## Detailed Site Plan Alternative Compliance Brighton Hills Condominiums

**DSP-94052-03**  
**AC-95023-01**

SUBJECT: Detailed Site Plan DSP-94052-03  
Alternative Compliance AC-95023-01  
Brighton Hills Condominiums

# LANDSCAPE PLAN

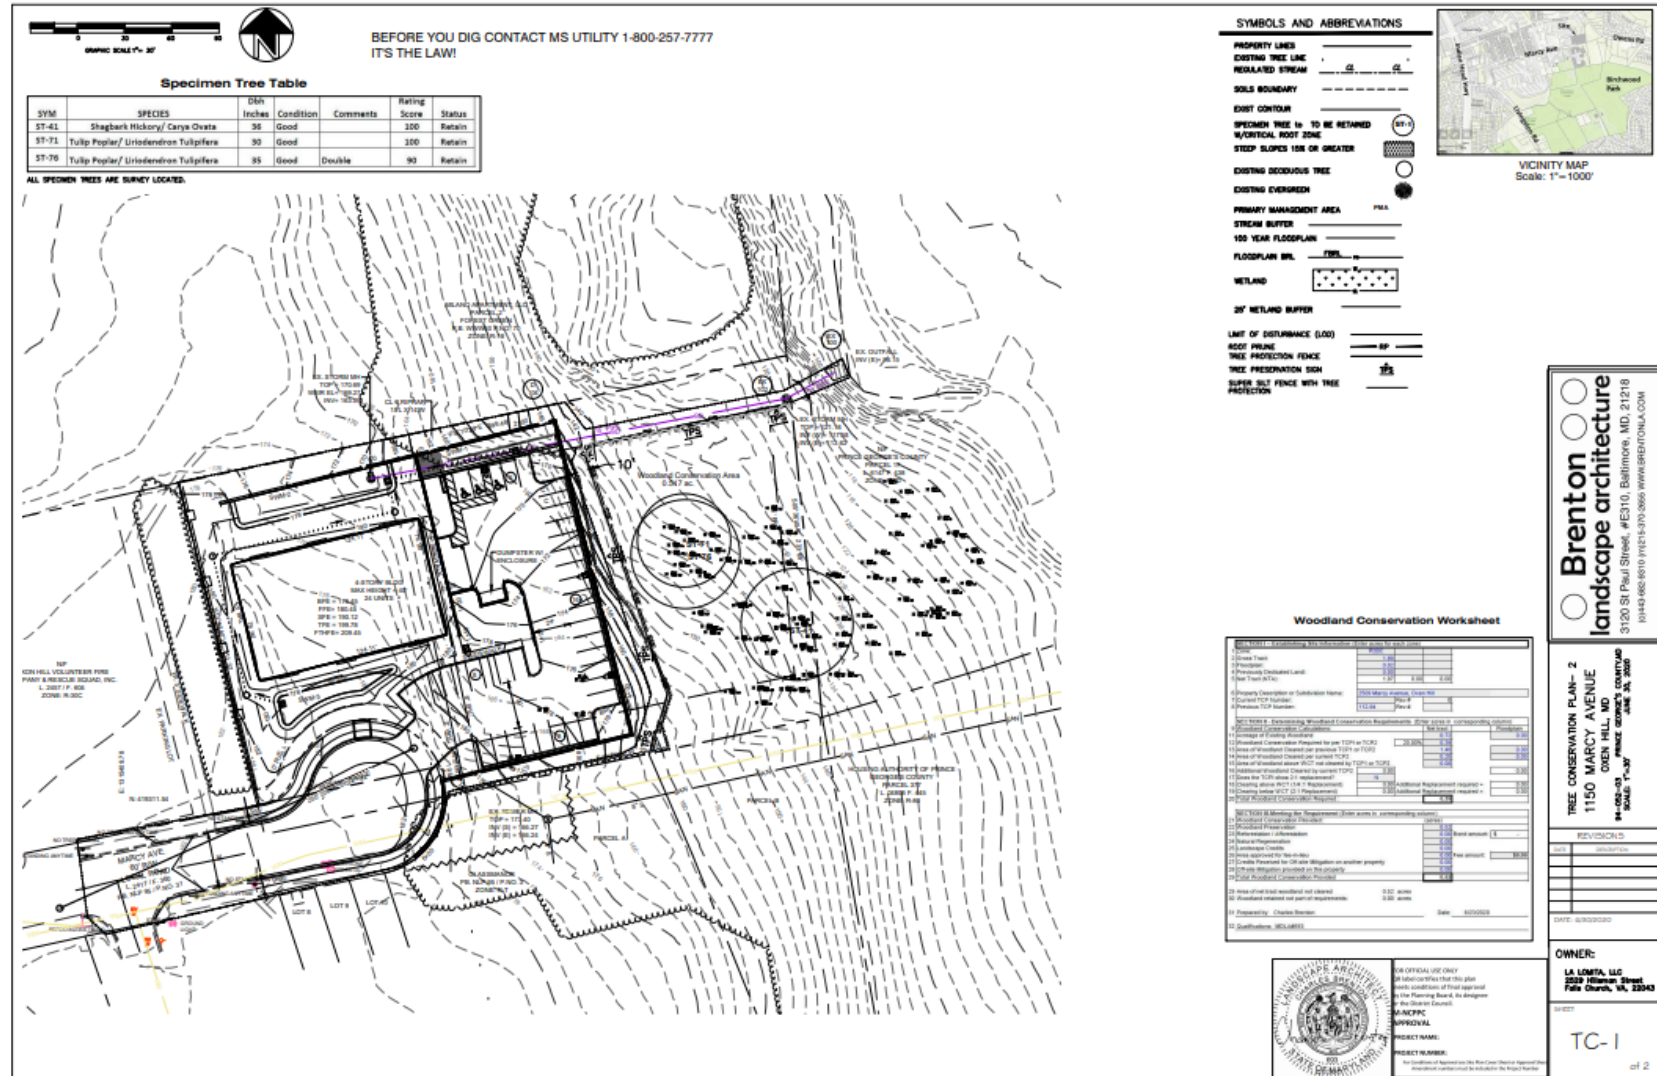
An existing townhouse development and vacant parcel are located along the southern boundary of the site. A Type “A” bufferyard is required, but a schedule has not been provided for this area. Staff notes that the landscape plan should be revised to add labels on the landscape plan showing conformance to this requirement.

- s. Revise the landscape plan and schedule to include an additional minimum of five evergreen trees along the western property line.
- t. Provide details of interior noise mitigation through the use of architectural and/or structural techniques along the western building facade.

- q. Revise Record Plat 173-26 referenced on the site plan under Parcel A, Brighton Hill, and correct the plat reference in the notes section.
- r. Revise the landscape plan to provide the additional plantings and schedules for Sections 4.3 and 4.7, in conformance with the 2010 Prince George's County Landscape Manual.

# EXTERIOR ELEVATIONS

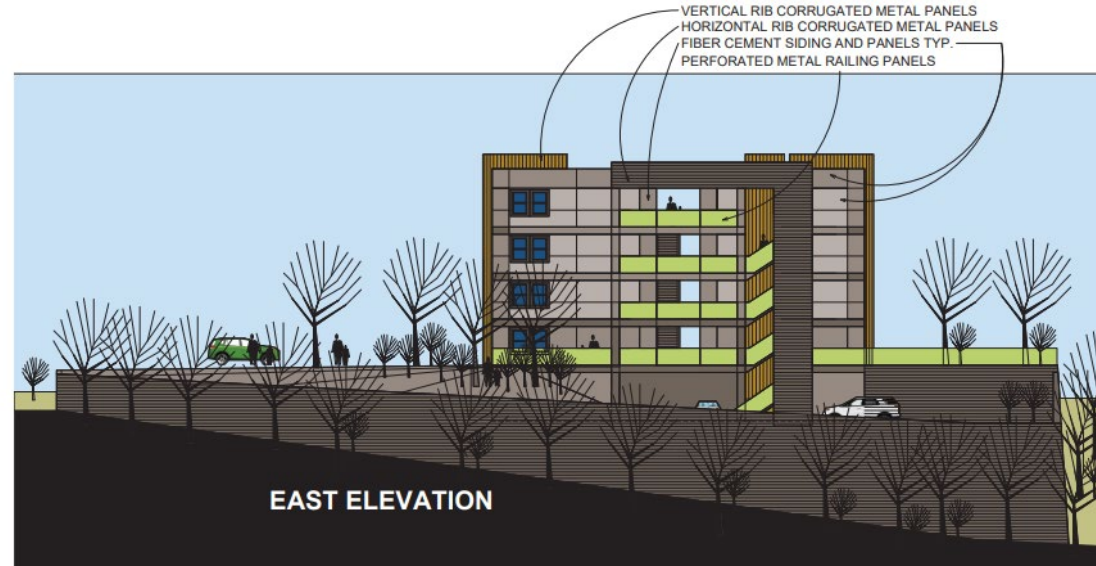
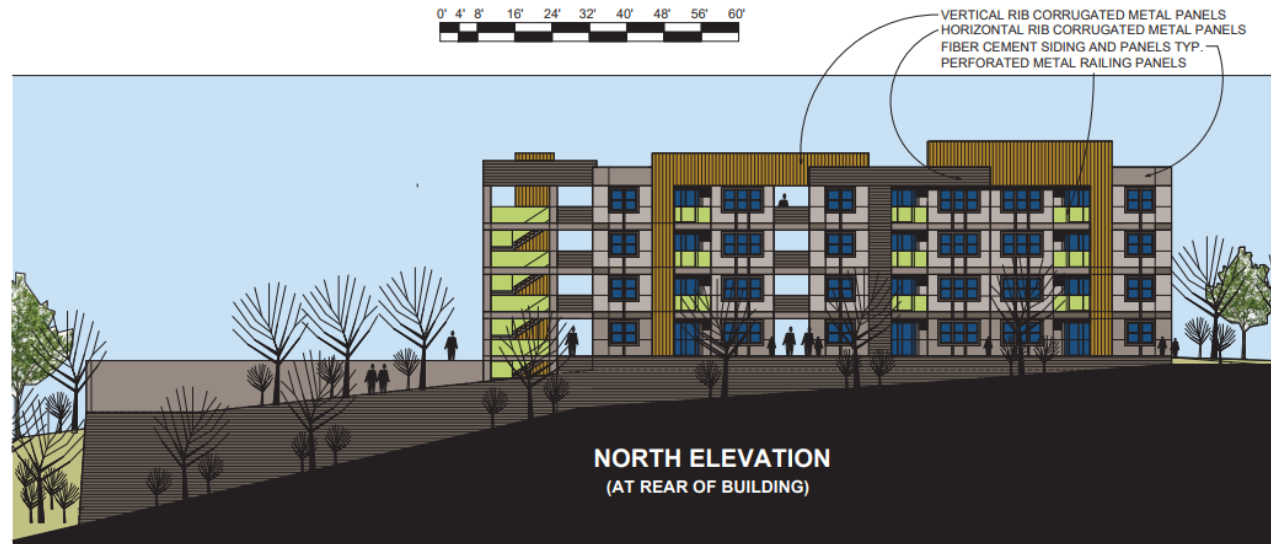
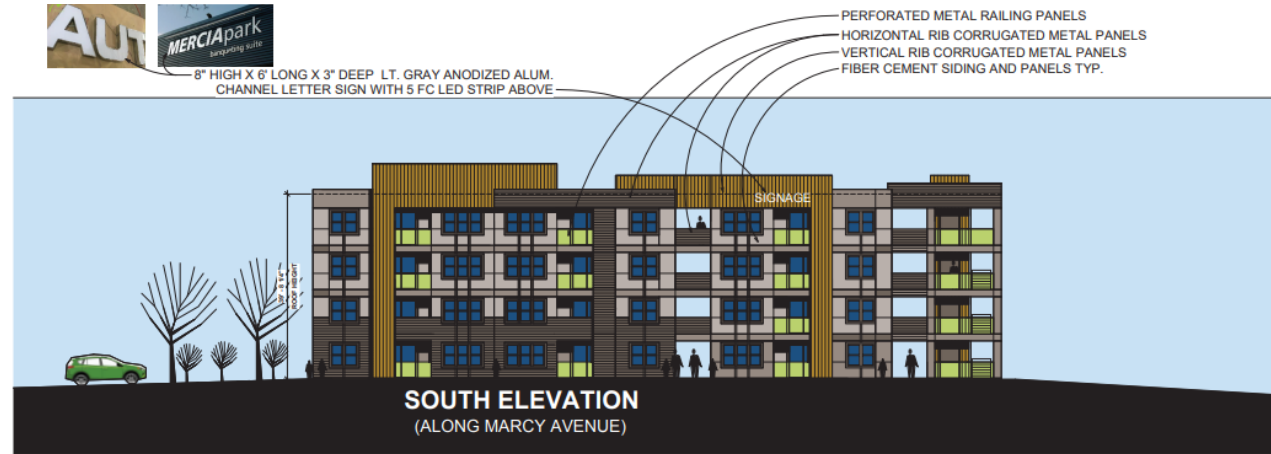
One building-mounted sign is proposed. The aluminum channel letter sign is illuminated and is approximately 8 inches high by 6 feet long. The submitted elevations show the sign on the southern building elevation, but details to fully evaluate the sign have not been provided. A condition has been included herein, requiring the applicant to provide scaled details of the signs and elevation drawings showing its design.

- j. Provide details of the trash enclosure and the building mounted sign, in accordance with prior Section 27-618 of the prior Prince George's County Zoning Ordinance.
